Shoalhaven Traffic Committee

Meeting Date: Tuesday, 12 December, 2017
Location: Jervis Bay Rooms, City Administrative Centre, Bridge Road, Nowra
Time: 9.30am

Agenda

TC17.82 - Attachment 1

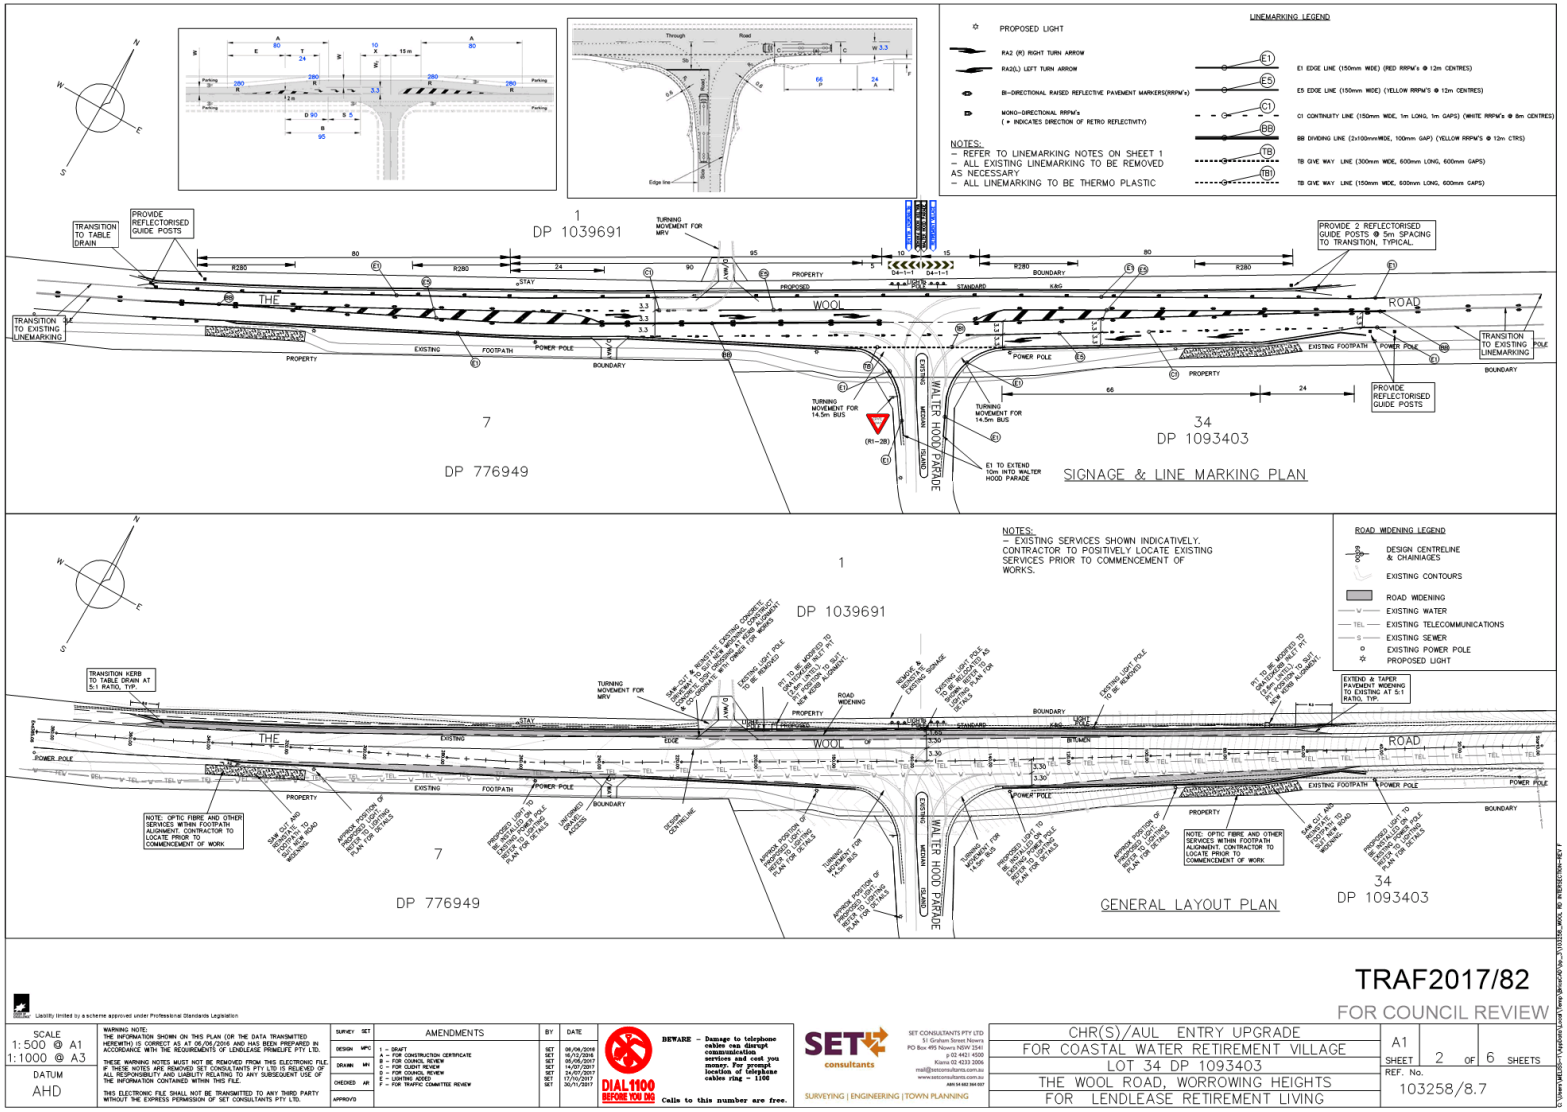
That that the General Manager (Director Assets and Works) be advised that the Shoalhaven Traffic Committee has no objection to the installation of a channelised right turn treatment (CHR), auxilary left turn (AUL) in, basic auxilary left (BAL) out and the associated signage and line marking at the intersecton of The Wool Road and Walterhood Parade, Worrowing Heights, as part of the Coastal Waters development as detailed in the attached plan TRAF2017/82.

Consistent with the development consent the applicant is required to upgrade the intersection of The Wool Road and Walterhood Parade, condition 6. of DS16/1154 requires the applicant to upgrade the intersection of The Wool Road and Walterhood Parade prior to further staging of the development.

6. Prior to the occupation of 100 residential units or more, the intersection with The Wool Road shall be upgraded to a fully channelised junction providing a "CHR", "AUL" in and "BAL" out for a design speed of 80 km/h. The pavement shall be designed for a traffic loading of 1 x 10^6 E.S.A. and surfaced AC. The channelised intersection shall be provided with kerb and gutter and associated stormwater drainage. The kerb radii shall provide for a 14.5 metre bus turning circle. The intersection shall be fully linemarked. The intersection with the Wool Road, and the approaches, shall be illuminated as a regional road in accordance with Australian Standard AS1158

TC17.83 - Attachment 1

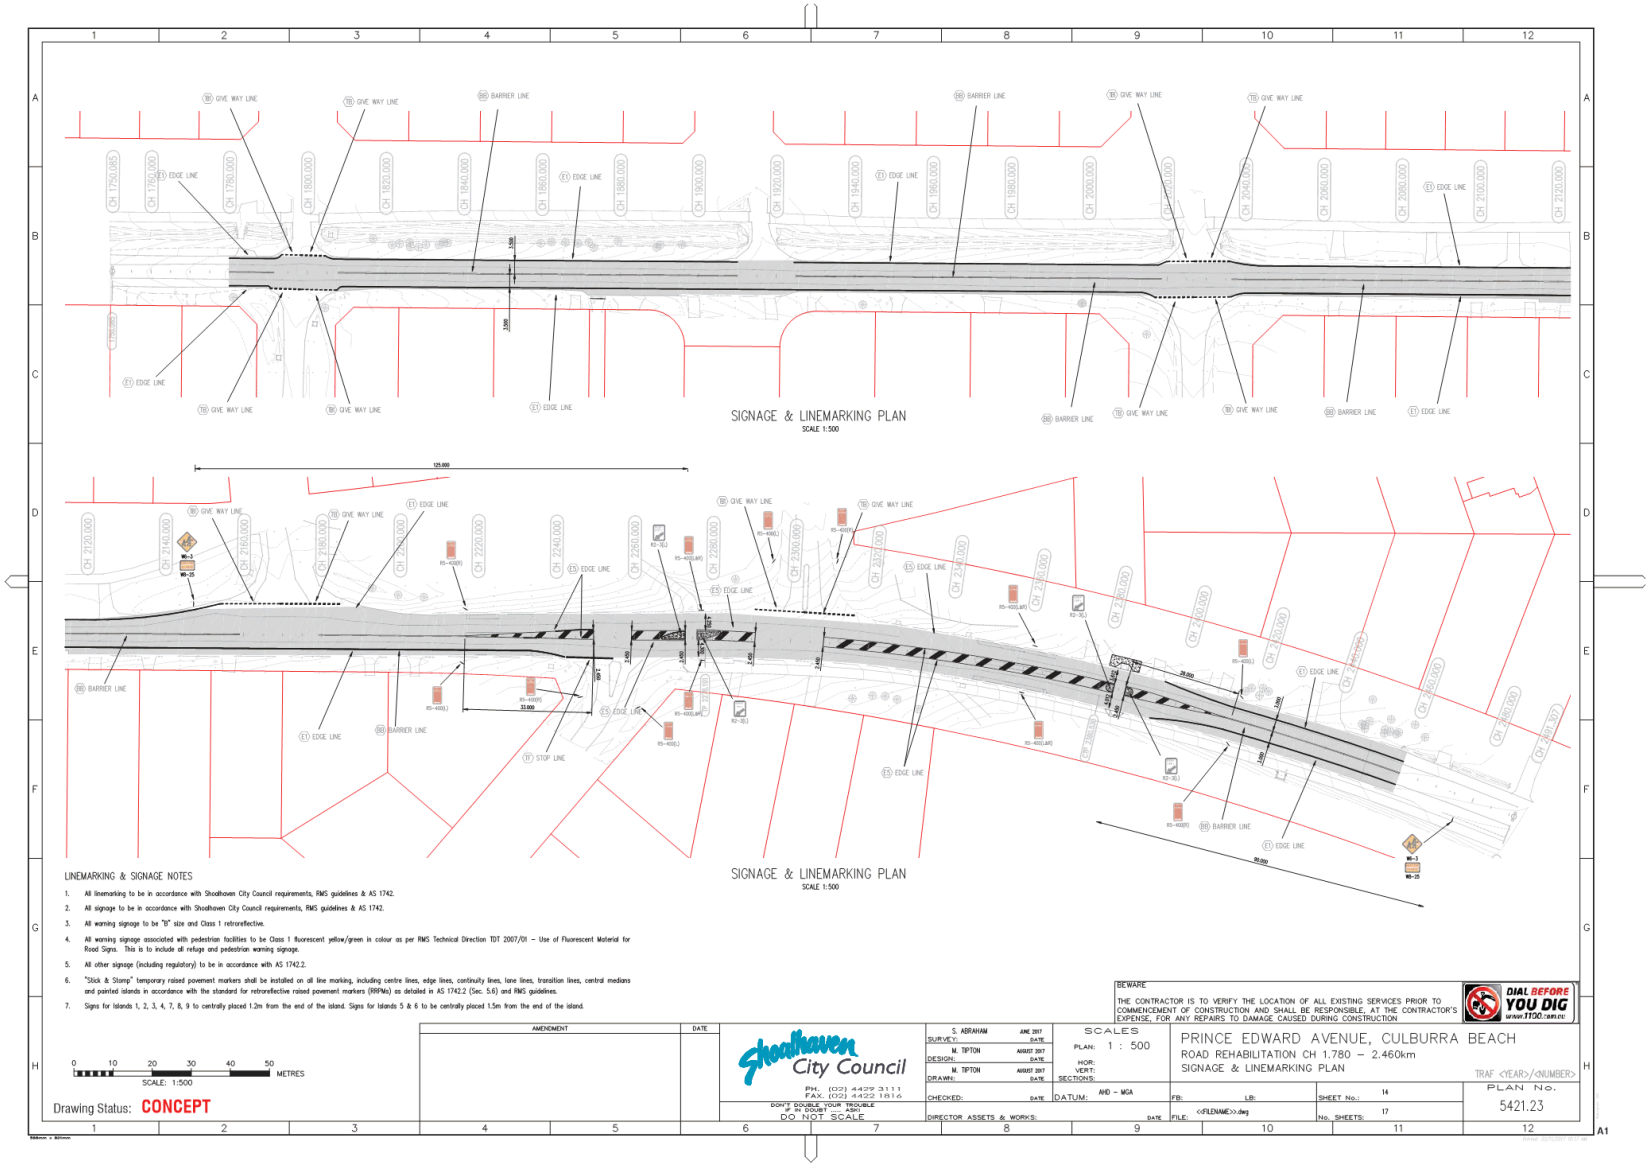
That the General Manager (Director Assets and Works) be advised that the Shoalhaven Traffic Committee has no objection to the installation of the proposed pedestrian refuge and associated signage and line marking on Prince Edward Avenue, Culburra Beach adjacent to the Curley's Bay Reserve as detailed in the attached plan TRAF2017/83.

The proposed road works require the removal of the existing slow points located either side of the Penguins Head Road intersection. In lieu of reinstating the slow points Council is proposing to install a pedestrian refuge adjacent to the Curley's Bay recreational skate park, in addition to the existing pedestrian refuge located on Prince Edward Avenue between Penguins Head Road and Whistler Street.

Six submissions were received. Two support the proposal and four supporting the proposal with some concern regarding parking provisions. Notably the proposal will remove approximately 4 on-street parallel parking spaces.

TC17.85 - Attachment 1

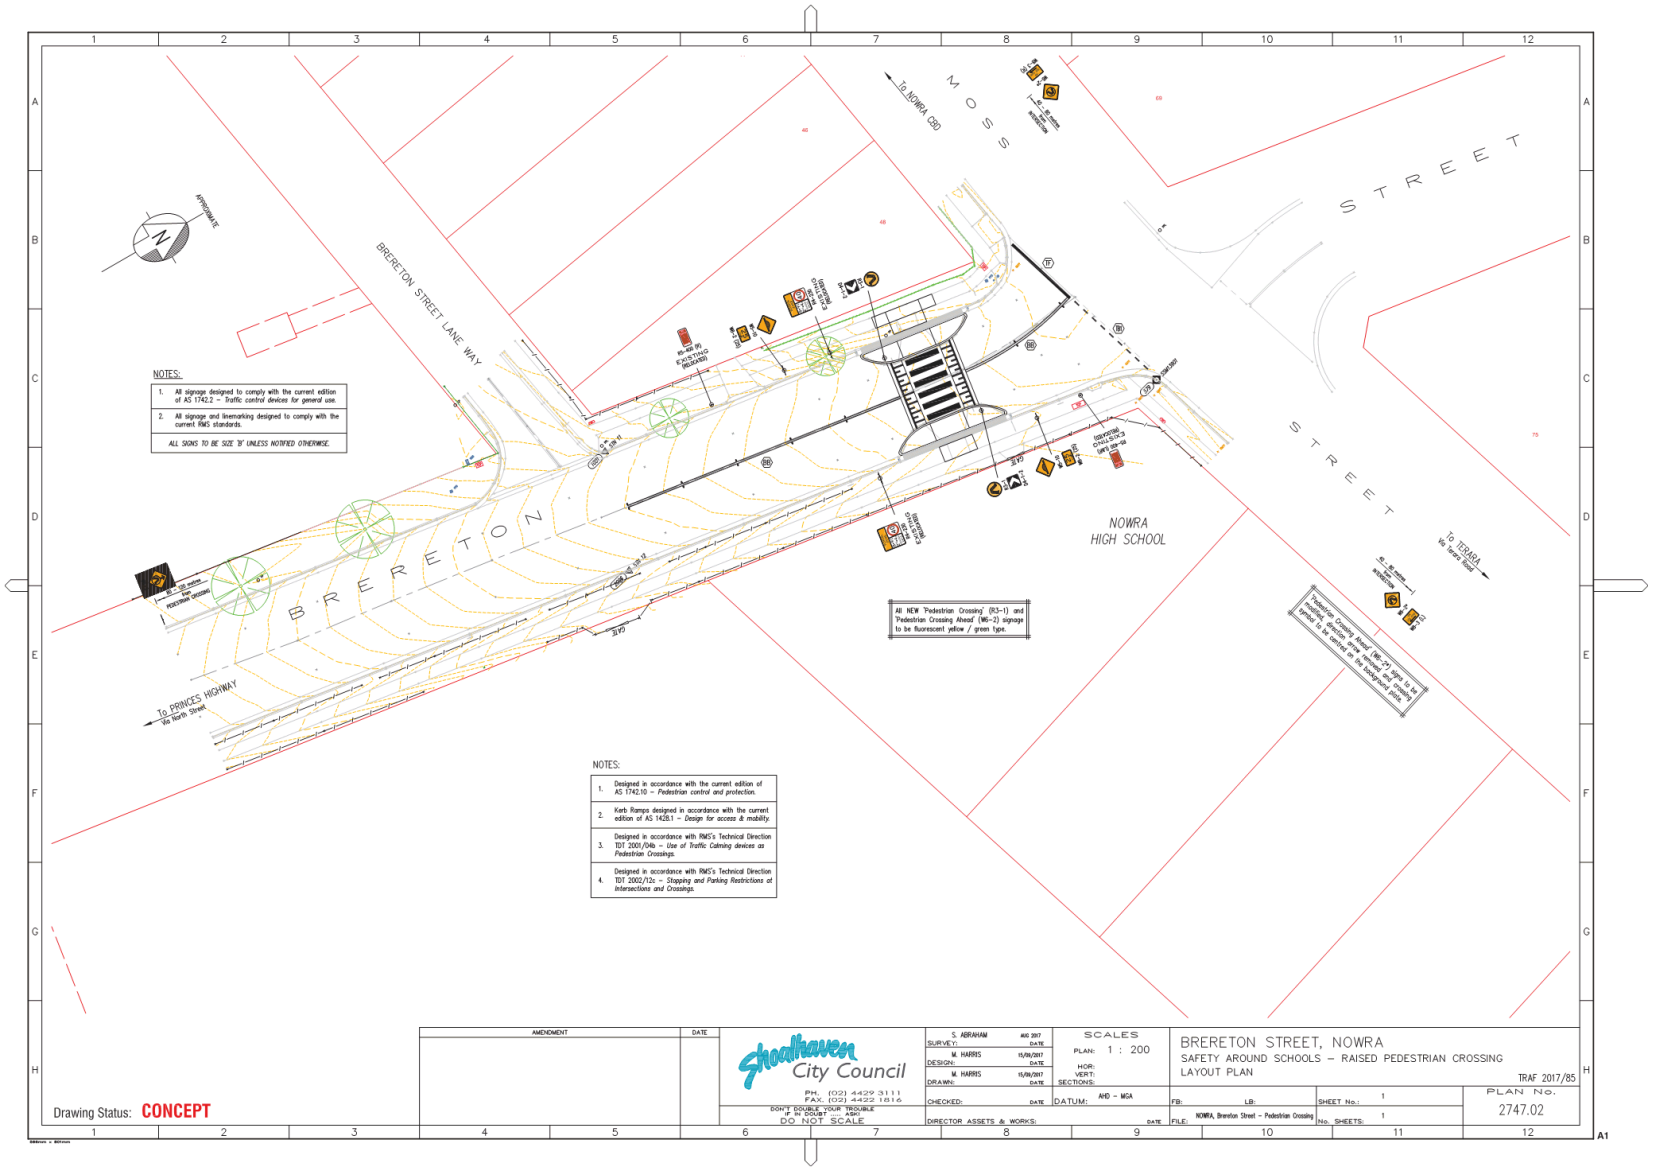
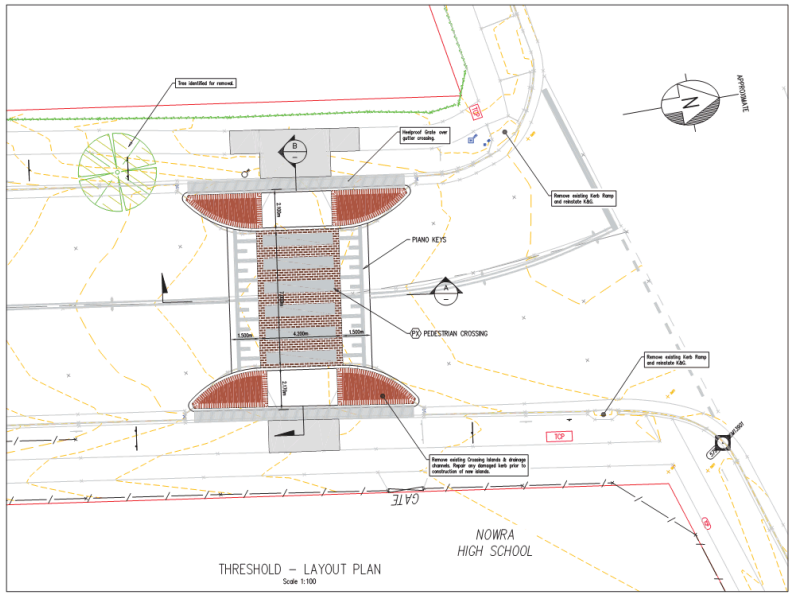
That the General Manager (Assets & Works) be advised that the Shoalhaven Traffic Committee has no objection to the proposed raised pedestrian crossing and associated signage and line marking on Brereton Street, Nowra as detailed in the attached plan TRAF2017/85(a & b) subject to the installation of zigzag advance pavement markings on the approaches.

TC17.87 - Attachment 1

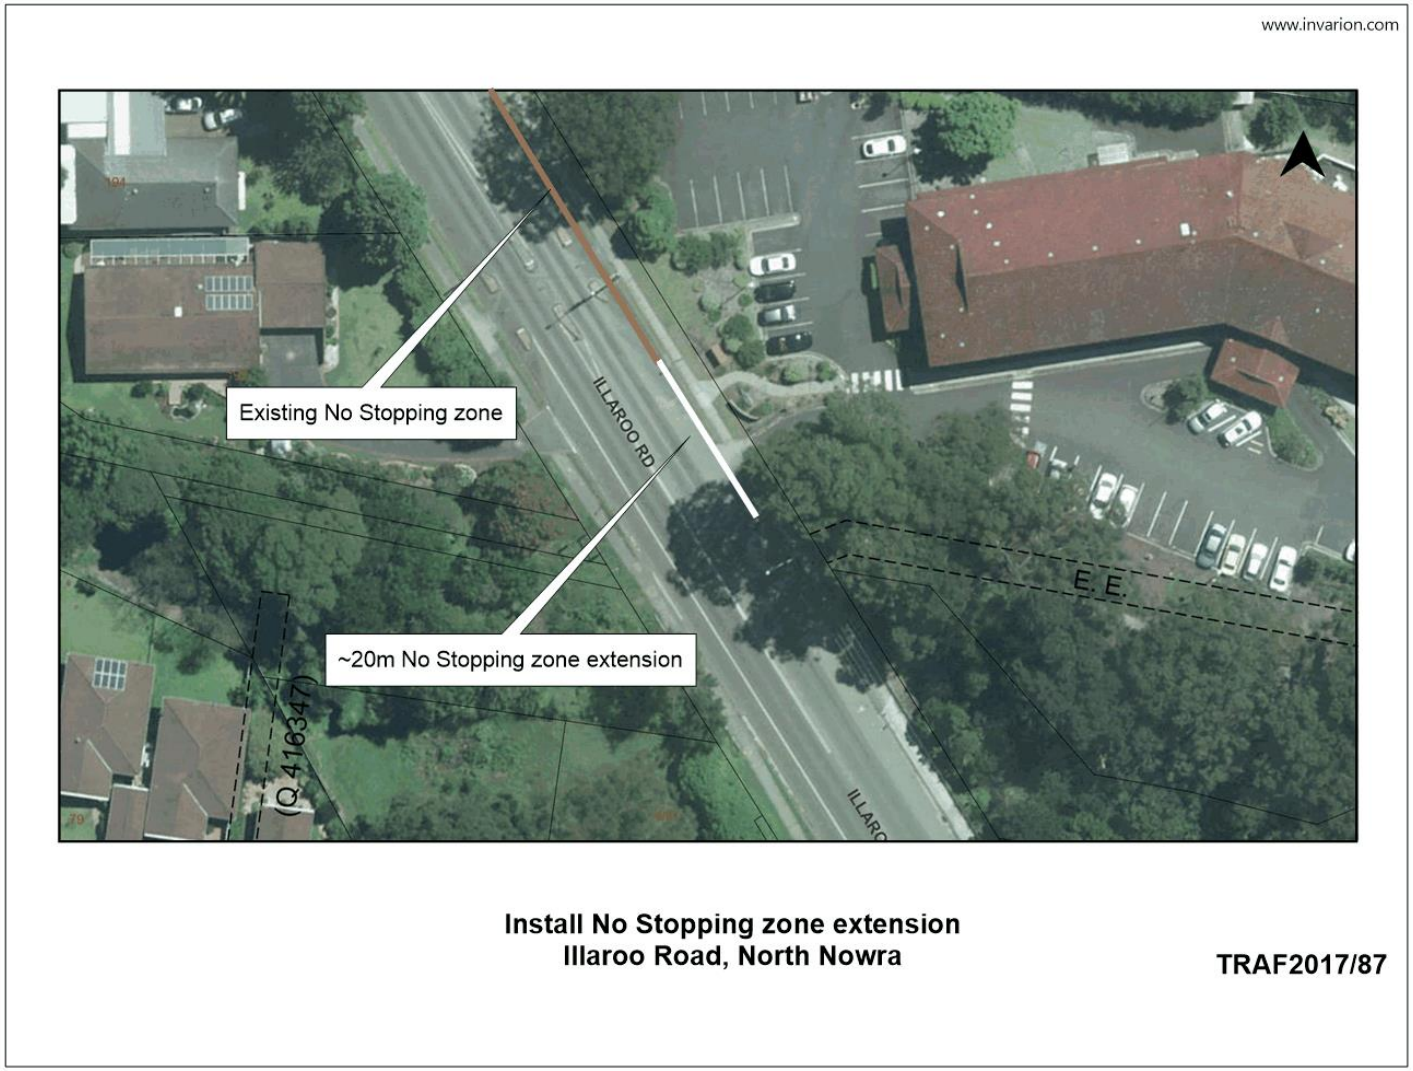
That that the General Manager (Director Assets and Works) be requested to arrange for the extension of the No Stopping zone 20m (approx.) south to the southern side of the Clelland Lodge driveway access, as detailed in the attached plan TRAF 2017/87.

In order to address the potential conflict in an emergency, Council is proposing to extend the existing eastern No Stopping zone 20m (approx.) south to the southern side of the Clelland lodge driveway access.

TRAF2017/88

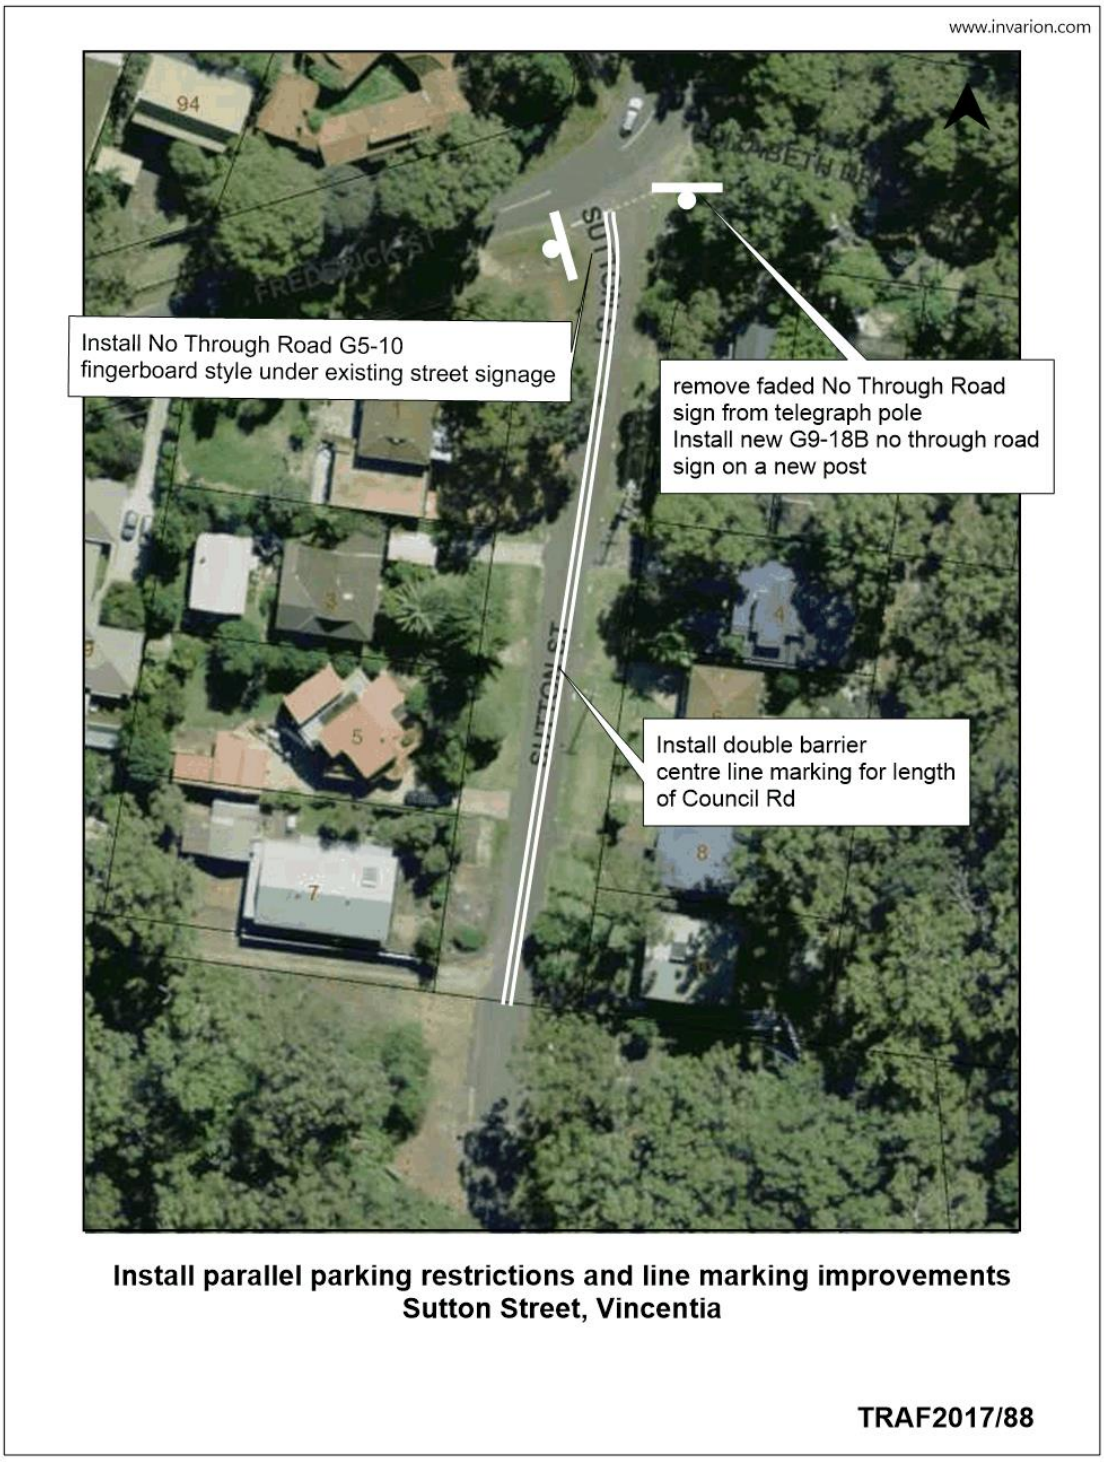
That Council rescind the previous motion (MIN 16.194) and that the General Manager (Director Assets and Works) be requested to arrange for the installation of following as detailed in the attached plan TRAF2017/88:

1. 100m (approx.) of double barrier centre line marking
2. 'No Through Road' signage at the intersection of Elizabeth Drive and Sutton Street.

a) Install 100m (approx.) of double barrier centre line marking
b) Install new 'No Through Road' signage at the intersection of Elizabeth Drive and Sutton Street.
c) Rescind the previous motion (MIN 16.194).
